# Access Compliance Report

## Public Rights-of-Way

### (Pedestrian Signals)

Intersection ID: N/A	Main Street:	Cross Street: N/A	Location: N/A
ADA ID: BBF33D50C701	Signal Type: One Push Button-APS	Overall Compliance: No	Severity Score: BTN 1: N/A BTN 2: N/A No BTN: N/A
Codes/Mitigation Info/Possible Solution		Field Measurements/Component Compliance

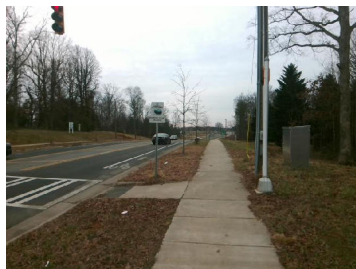
PROW/ADA: TMUTCD 4e.08, R404.7.3, R209.1, MUTCD 4e.10

N/A	B 1 FWD Approach Width (in)	N/A	N/A	B 2 FWD Approach Width (in)	N/A
N/A	B 1 FWD Approach Obstruction?	Yes	N/A	B 2 FWD Approach Obstruction?	N/A
N/A	B 1 FWD Approach Obstruction Dist (in)	5.0	N/A	B 2 FWD Approach ObstructionDist (in)	N/A
N/A	B 1 PARA Approach?	Yes	N/A	B 2 PARA Approach?	N/A
N/A	B 1 PARA Approach Constrained?	Yes	N/A	B 2 PARA Approach Constrained?	N/A
No	B 1 PARA Approach Reach (in)	13.0	N/A	B 2 PARA Approach Reach (in)	N/A
Yes	B 1 PARA Approach Width (in)	60.0	N/A	B 2 PARA Approach Width (in)	N/A
N/A	B 1 PARA Approach Obstruction?	Yes	N/A	B 2 PARA Approach Obstruction?	N/A
N/A	B 1 PARA Approach Obstruction Dist (in)	5.0	N/A	B 2 PARA Approach ObstructionDist (in)	N/A
Yes	B 1 Clear Floor Space Slope (%)	1.9	N/A	B 2 Clear Floor Space Slope (%)	N/A
Yes	B 1 Clear Floor Space XSlope (%)	0.6	N/A	B 2 Clear Floor Space XSlope (%)	N/A
N/A	B 1 PAR Slope (%)	N/A	N/A	B 2 PAR Slope (%)	N/A
Yes	B 1 Height (in)	31.0	N/A	B 2 Height (in)	N/A

N/A B 1 Clear Xing Direction?	Yes	N/A B 2 Clear Xing Direction?	N/A
B 1 Crossing Direction	To E	B 2 Crossing Direction	N/A
Yes B 1 DistanceTo XWalk (in)	0.0	N/A B 2 DistanceTo XWalk (in)	N/A
No B 1 DistanceTo Curb (in)	171.0	N/A B 2 DistanceTo Curb (in)	N/A
Yes B 1 Diameter (in)	2.0	N/A B 2 Diameter (in)	N/A

Possible Solutions: Replace Signal Push Button With APS Button on New Post. Remove & Relocate Sign.
